平陆县 100MW 农光互补光伏发电项目

监理工程师通知单

编号: ZHJL-JLTZ-PL-192

主题: 2025 年 3 月 23 日建设单位、监理单位及总包单位在洪池地块 29 区、32 区验收过程中发现以下问题:

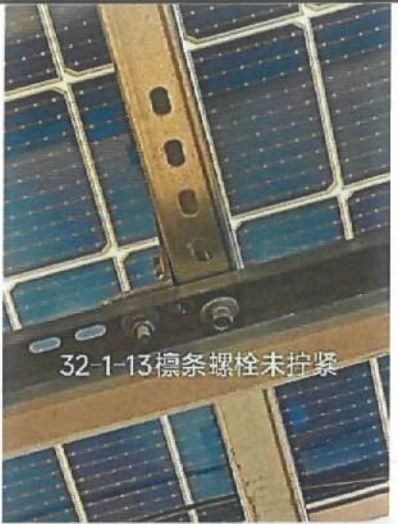
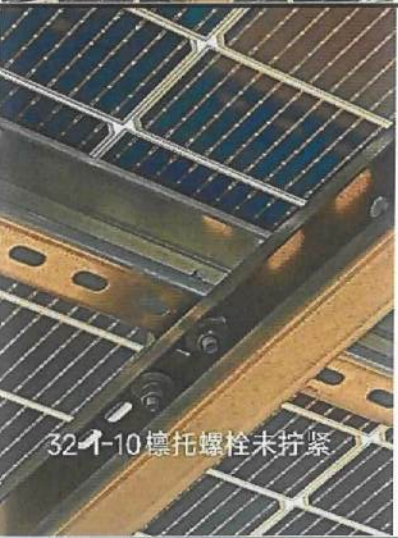
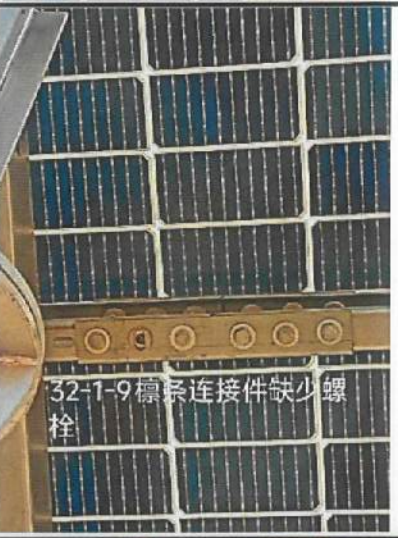
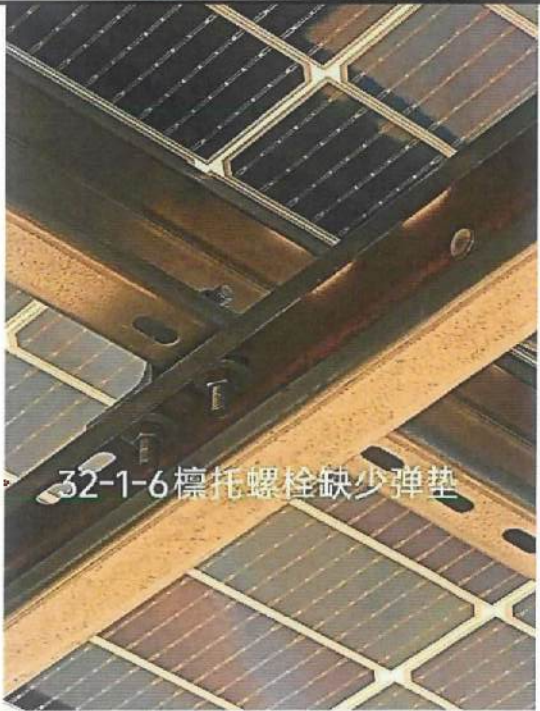
1	 32-2-1小弹垫	2	 32-2-1缝隙太大
3	 32-1-27斜槽条弯曲	4	 32-1-25少平少弹少母

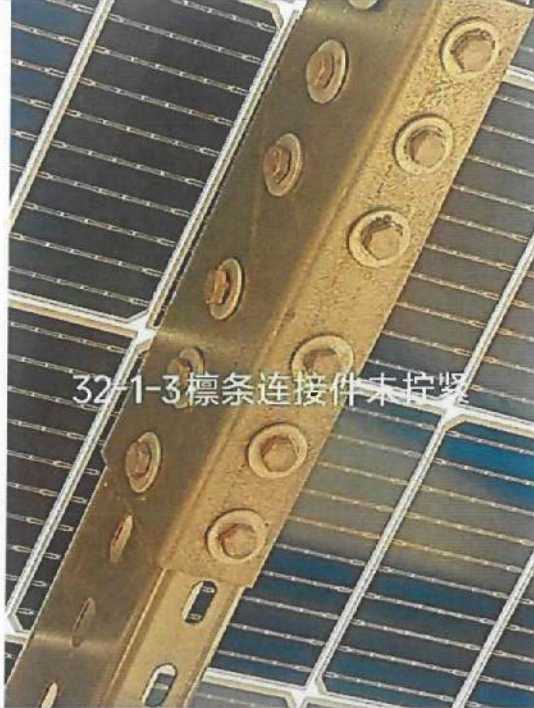
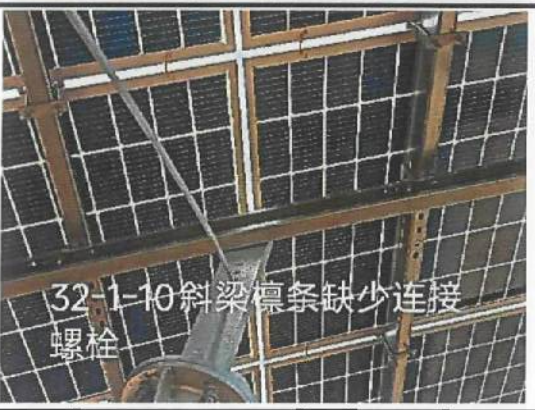
5	 32-1-24斜槽条弯曲及撑托调整	6	 32-1-28二次灌胶没做
7	 32-1-28支架没接地线	8	 32-1-28少黄绿线接地
9	 32-2-8螺栓没紧	10	 32-2-17螺栓没紧
11	 32-2-14螺栓没紧	12	 32-2-24螺栓没紧

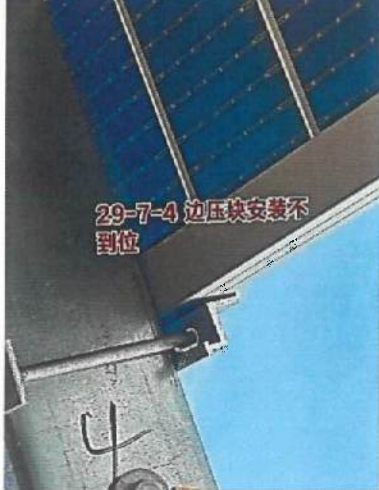
59	 32-2-22 左边增补组斜梁弯曲	60	 32-2-21 檩条连接件缺少平垫
61	 32-2-20 抱箍未拧紧	62	 32-2-20 抱箍未拧紧
63	 32-2-20 檩条螺栓缺少弹垫	64	 32-2-19 抱箍未拧紧

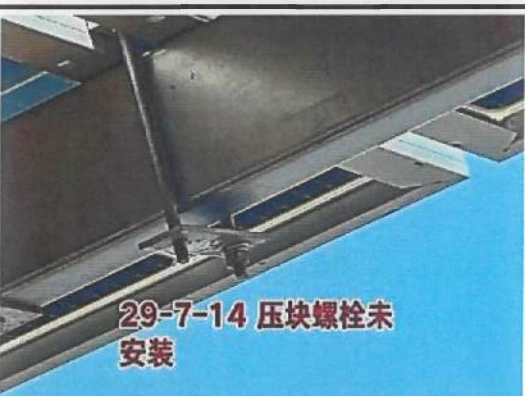
65	 32+2-19斜撑未拧紧	66	 32-8-2抱箍弹垫损坏
67	 32-4-19压块间隙多处	68	 32-4-20螺丝松动
69	 32-4-20压块未贴紧	70	 32-4-26压块间隙多处
71	 斜撑抱箍连接处未紧合	72	 32-7-23横托螺丝松动

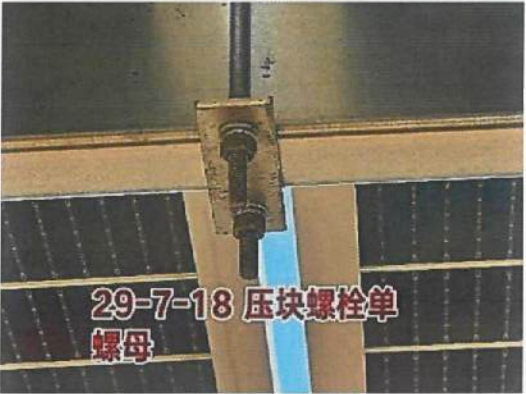
73	 32-5-29 槽托螺丝少垫片弹 垫未出丝	74	 32-5-22 缺少垫片弹垫
75	 32-5-23 槽托螺丝松动	76	 32-5-16 槽托螺丝松动
77	 32-5-14 螺丝松动	78	 32-5-23 槽托螺丝松动 通病
79	 32-5-2 槽托无螺丝	80	 32-2-26 槽托螺丝未紧

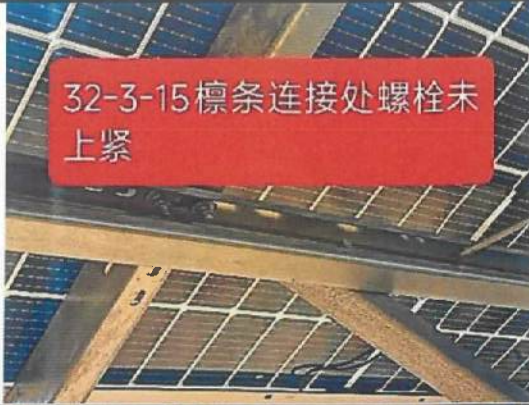
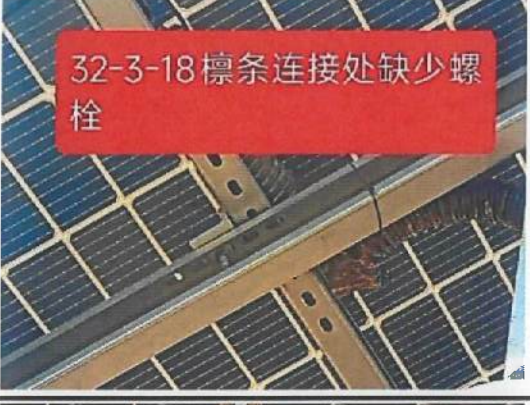
89	 32区69号托架缺螺丝	90	 32区69号托架少两颗螺丝
91	 32区69号托架缺螺丝	92	 52区69号托架缺螺丝
93	 32区69号托架缺螺丝	94	 32区逆变器未做标识

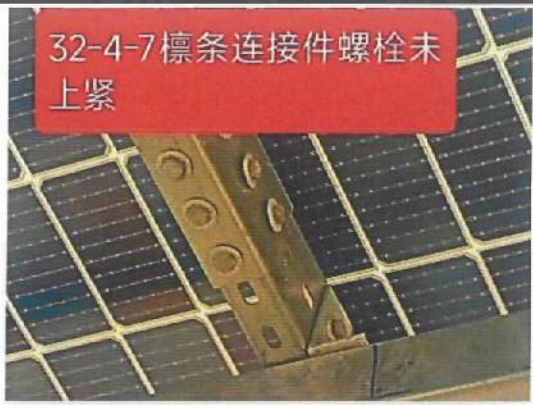
107	 29-7-6左侧增补组串 檩条连接件缺少螺栓	108	 29-7-10 压块螺栓未 紧固
109	 29-7-11压块螺栓未紧 固	110	 29-7-12 压块螺栓单 螺母
111	 29-7-14 压块螺栓未 安装	112	 29-7-14 檩托螺栓未 紧固
113	 29-7-15 檩条螺栓平 垫生锈	114	 29-7-15边压块螺栓未 紧固
